REMARKS

AMENDMENTS TO THE DRAWINGS

Appln. No. 09/400,549
Admend. Dated 08/26/04
Reply to Office Action of 03/26/04
Annotated Sheet

FIG. 1 PRIOR ART

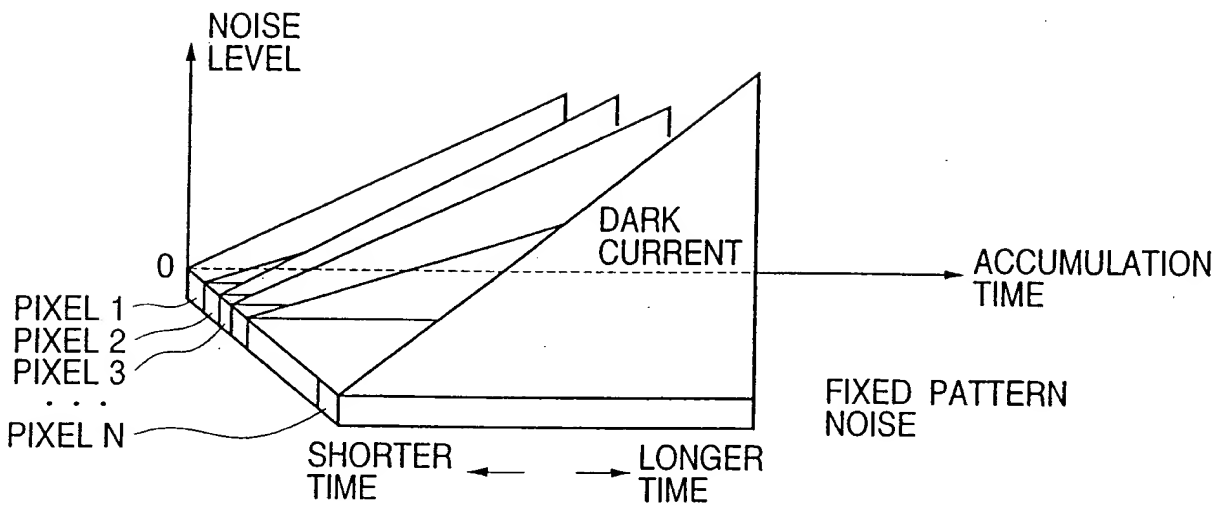
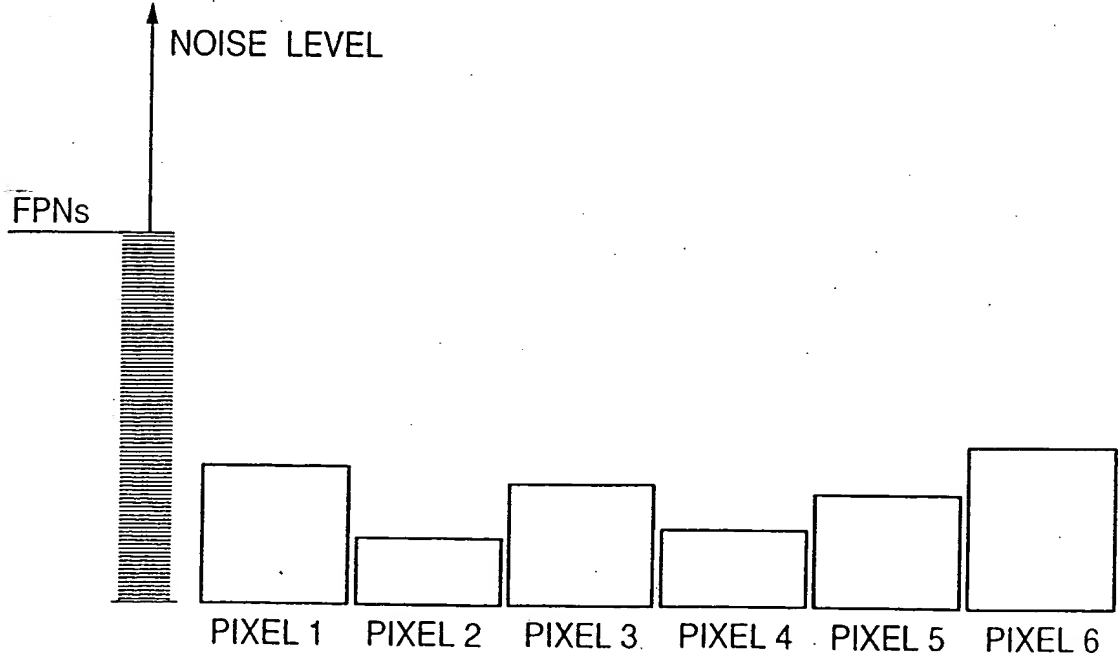
Figures 1, 2, 3, and 7A-C have been labeled "Prior Art".

FIG. 6A

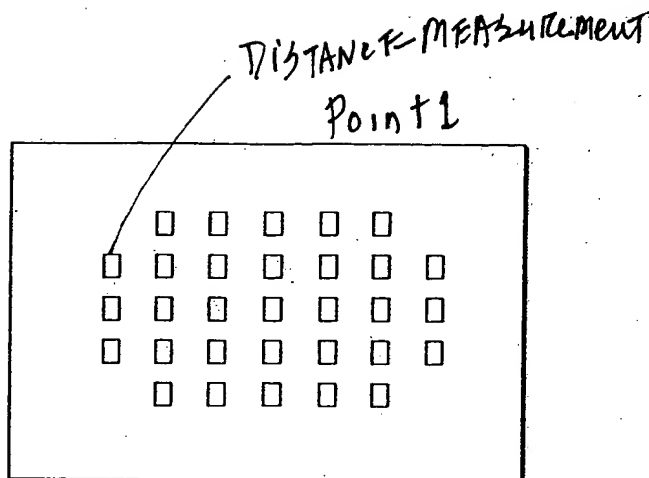
As to the term "distance measurement point 1" at page 21, line 6 of the specification, Applicant has amended Figure 6A to identify this element. Applicant also has the following comments regarding this element. The distance measurement point 1 recited at page 21, line 6, is one of a number of distance measurement areas described at page 11, line 12, of the specification, and thus is clearly shown in Figure 6A.¹ Support for this element may also be found at least at page 11, line 9, to page 12, line 2, and from page 20, line 18, to page 21, line 23.

In Figure 6A, Applicant has amended this figure to identify a "Distance Measurement Point 1".

FIG. 7B

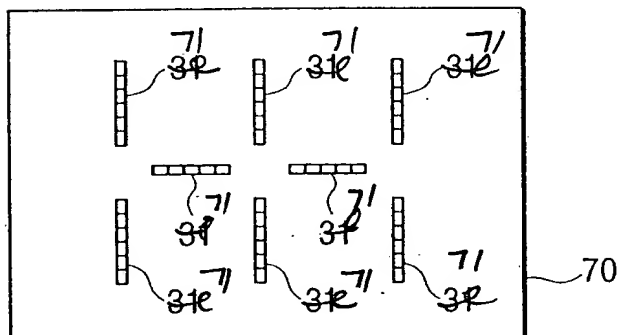
Figure 7B has also been amended to change reference designator "31" to read --71--, so as to be consistent with the specification.
